World Forum for Harmonization of Vehicle Regulations

158th session

1958 Agreement – Consideration of draft amendments to existing Regulations submitted by GRSG

Proposal for the 01 series of amendments to Regulation No. 125 (Forward field of vision of drivers)

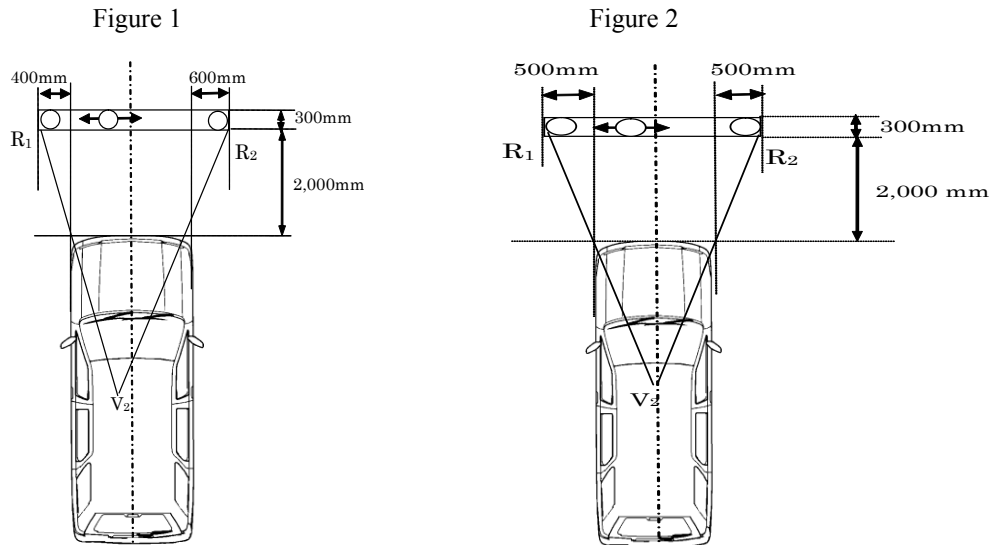
Insert a new paragraph 5.1.4., including new figures 1 and 2, to read:

"5.1.4. In the case where the height of V2 above the ground exceeds 1,650 mm, the following requirement shall be met:

A 1,200 mm tall cylindrical object with a diameter of 300 mm that is situated inside the space bounded by a vertical plane located 2,000 mm in front of the vehicle, a vertical plane located 2,300 mm in front of the vehicle, a vertical plane located 400 mm from the driver's side of the vehicle, and a vertical plane located 600 mm from the opposite side of the vehicle shall be at least partially visible when viewed directly from V2 (see figure 1), regardless of where the object is within that space, unless it is invisible due to a blind spot(s) created by the A pillars, windscreen wipers, or steering wheel.

If the driver's seat is located in the central driving position of the vehicle, the 1,200 mm tall cylindrical object shall be situated inside the space bounded by a vertical plane located 2,000 mm in front of the vehicle, a vertical plane located 2,300 mm in front of the vehicle, a vertical plane located 500 mm from the side of the vehicle (see figure 2).

"Annex 2

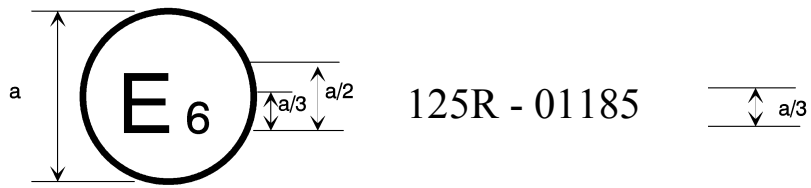
Annex 2, amend to read:

a = 8 mm min

The above approval mark affixed to a vehicle shows that the vehicle type concerned has been approved in Belgium (E6) with regard to the driver's forward field of vision pursuant to Regulation No. 125. The first two digits of the approval number indicate that the approval was granted in accordance with the requirements of Regulation No. 125 as amended by the 01 series of amendments."
